January 5, 2018

Amended: February 2, 2018

**RE: Amended Zone Change Application –Response to Staff Report
Mercedes-Benz of Cincinnati
8727 Montgomery Road
Cincinnati, Ohio 45236** **Sycamore 2018-02Z Mercedes-Benz Expansion**

SIGNAGE ELEVATION - GROUND

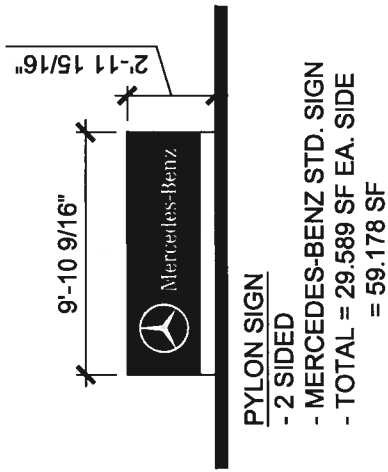
- j. Per Section 13-5.3 Minimum Setback, signs shall be a minimum of 10' from the right-of-way. Dimension to ground sign not provided.

- k. Per Section 13-5.11 Sign Base, a base made up of stone, brick or other architecturally compatible base material. As submitted, material unknown.

- l. Per Section 13-12.3 Freestanding Signs, based on street frontage, the applicant would be permitted 64 S/F of signage. Applicants sign calculations should be revised to reflect the Zoning Resolution requirements.

Response: The ground sign dimensions have been added to drawing SP1.00 showing a 15' setback. A copy of this portion of our revised drawing is attached to this response. Sketch 'A'.

Response: The base material has been added in notations to drawing SP1.00 showing a stone base. A copy of this portion of our revised drawing is attached to this response. Sketch 'B' notes this revision.

Response: There is no signage proposed on the rezoned lot. For the existing building lot, we are proposing one (1) freestanding ***ground*** sign with ***29.589 SF each face for a total of 59.178 SF (Maximum allowed = 64 SF)*** of sign area total for the two faces. A copy of this portion of our revised drawing is attached to this response. Sketch 'B'. Note: On all signage issues, we are willing to work with staff to find the correct balance of area, location and presentation.

SIGNAGE ELEVATION - BUILDING

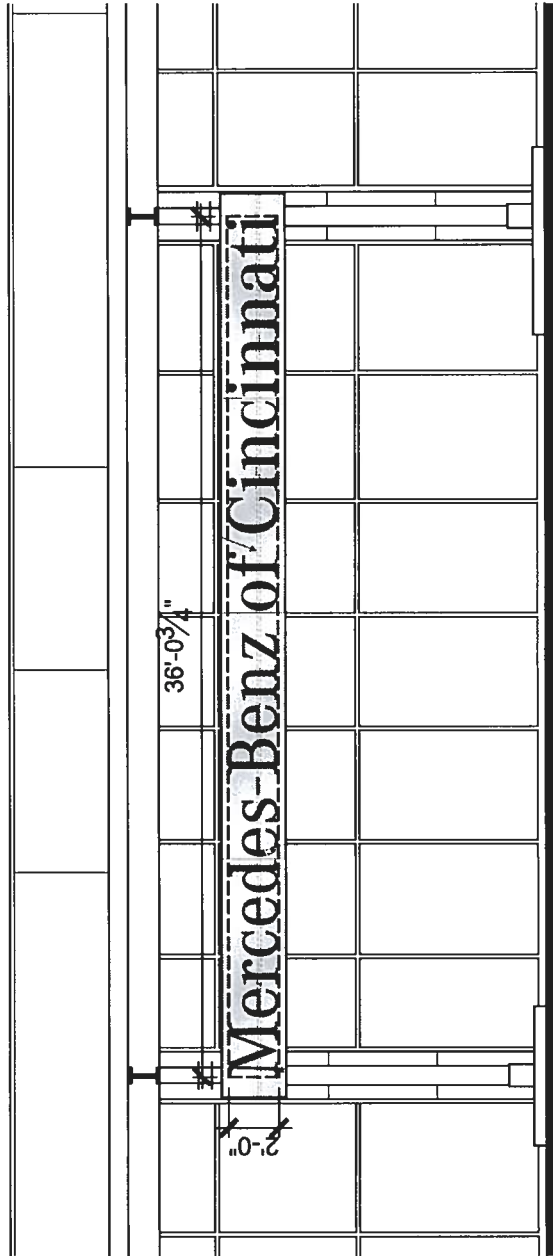
- m. Per Section 13-12.4(a) Building Signs, applicant is permitted building signage at a 1 to 1 ratio. No more than 2 signs per building with a maximum of 150 S/F. The applicant is proposing 3 building signs totaling approximately 180 S/F. Applicants sign calculations should be revised to reflect the Zoning Resolution requirements.

Response: We are requesting a variance to add one (1) building sign for the 'Star' on the second face of the new 'blade'. ***Each 'Star' is 36 SF, the two stars equal 72 SF. The 'Mercedes-Benz of Cincinnati' sign on the front of the building has a sign***

area of 72.125 SF. This produces a total building sign area of 144.125 SF which is below the allowed 150 SF. A copy of this portion of our original drawing is attached to this response. Sketch 'C' shows the blade information. Our sketch 'B' is amended to support this analysis. We request a variance for the third building sign for the added Star on the blade.
